East Venice Community Plan Proposed VNC Recommendations

August 2026

Presentation by the VNC's Community Plan/Local Coastal Program
Ad Hoc Committee

7. Venice Blvd from Walgrove Ave to Lincoln Blvd (Community Center)

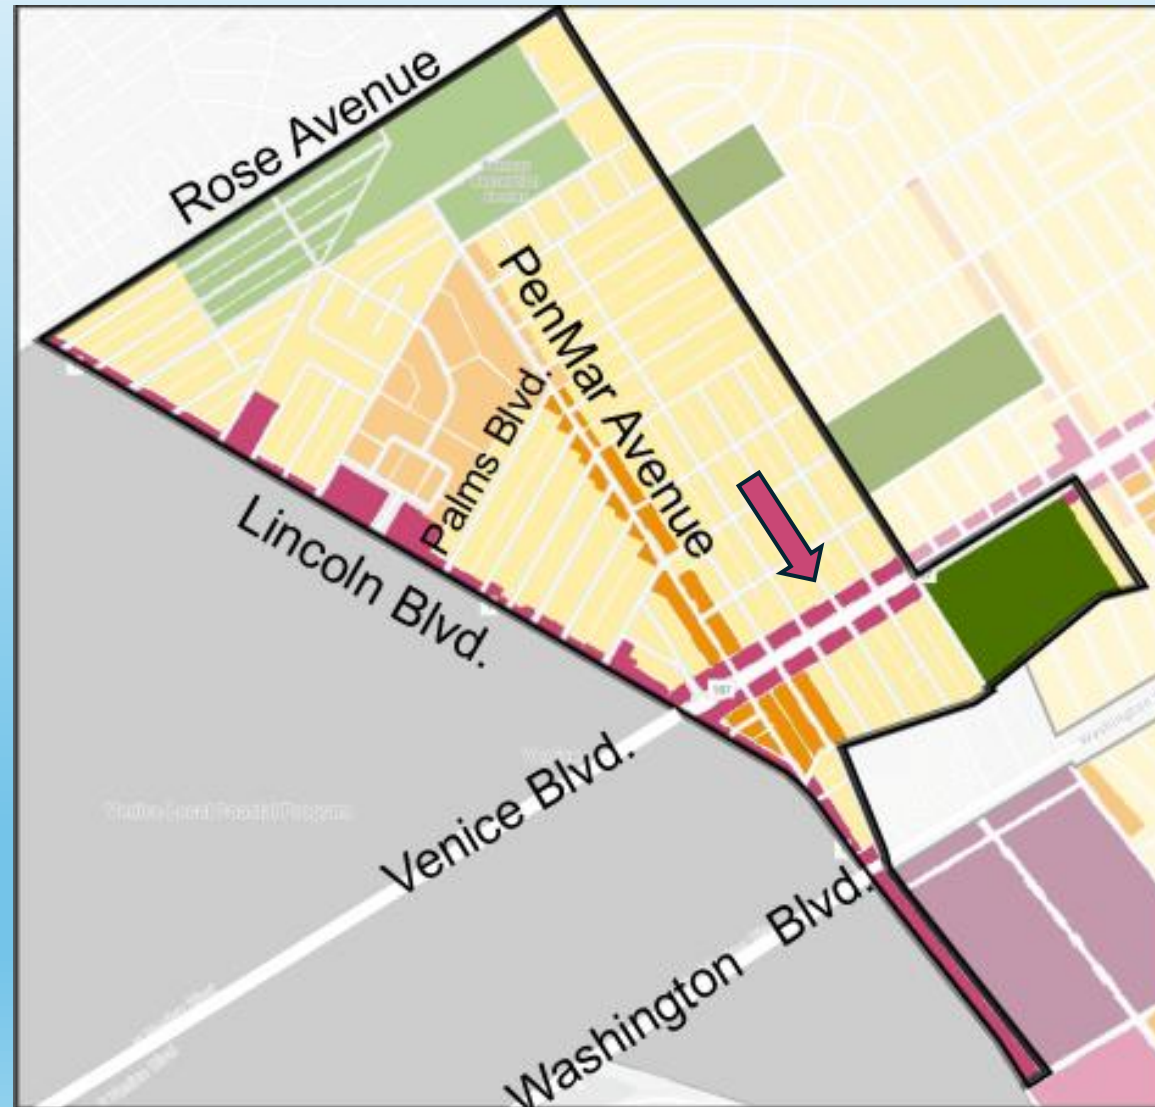
Comparison of VNC 2024, City Planning 2026, and VNC 2026	Density - DU/Lot (excluding ADUs)	Maximum Height: Tier 1 Bonus Tier 2 Bonus	Floor Area Ratio (FAR): Tier 1 Bonus Tier 2 Bonus
VNC Recommendation (2024)	800SF/DU	3 stories, ≤33' (5 stories, ≤55' with bonus)	1.25 (2.0 with bonus)
City Planning Proposed (2026)	1 DU/400 SF of lot	3 stories (Tier 1 bonus = 7 or 8) (Tier 2 bonus = 8 or 10)	1.5 (Tier 1 bonus: 4.5 or 5.0) (Tier 2 bonus: 5.0 or 5.5)
Revised VNC Recommendations (2026)	800SF/DU	3 stories, ≤33' (Tier 1 bonus = 5 stories, ≤55')	1.25 (Tier 1 bonus = 2.0)

Change from VNC 2024 Recommendation – no change

8. Lincoln Blvd from Washington Blvd to Maxella Ave (Community Center)

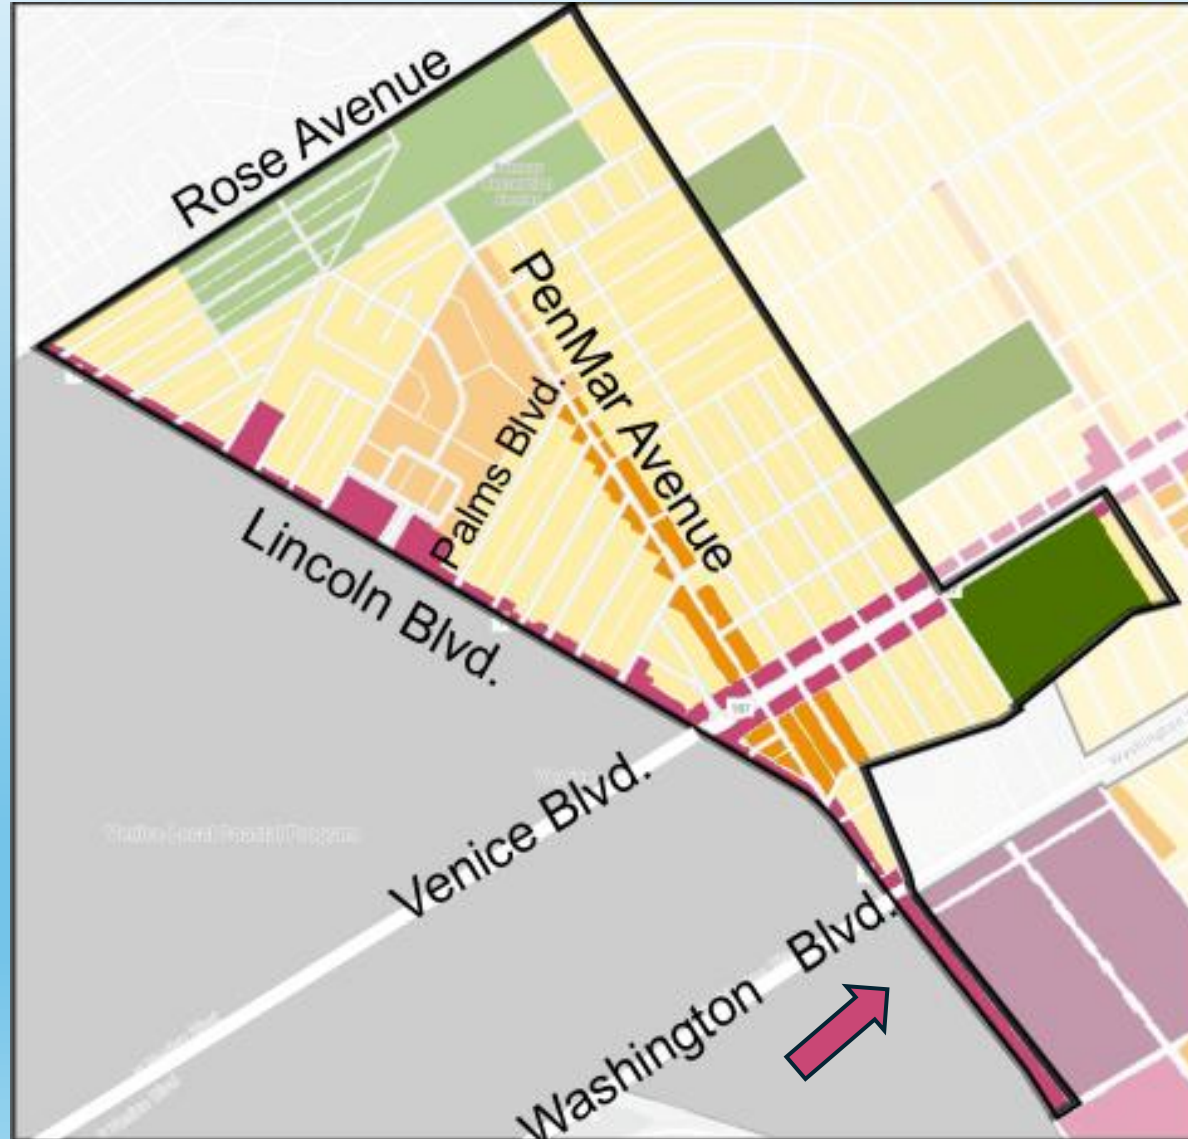
Comparison of VNC 2024, City Planning 2026, and VNC 2026	Density - DU/Lot (excluding ADUs)	Maximum Height: Tier 1 Bonus Tier 2 Bonus	Floor Area Ratio (FAR): Tier 1 Bonus Tier 2 Bonus
VNC Recommendation (2024)	800SF/DU	3 stories, ≤33' (5 stories, ≤55' with bonus)	1.0 (1.5 with bonus)
City Planning Proposed (2026)	1 DU/400 SF of lot	3 stories (Tier 1 bonus = 6)	1.5 (Tier 1 bonus = 4.0)
 Revised VNC Recommendations (2026)	800SF/DU	3 stories (Tier 1 bonus = 6) (Tier 2 bonus = 8)	1.5 (Tier 1 bonus: 3.5) (Tier 2 bonus: 5.0)

Change from VNC 2024 Recommendation – increased to 8 stories, 5 FAR
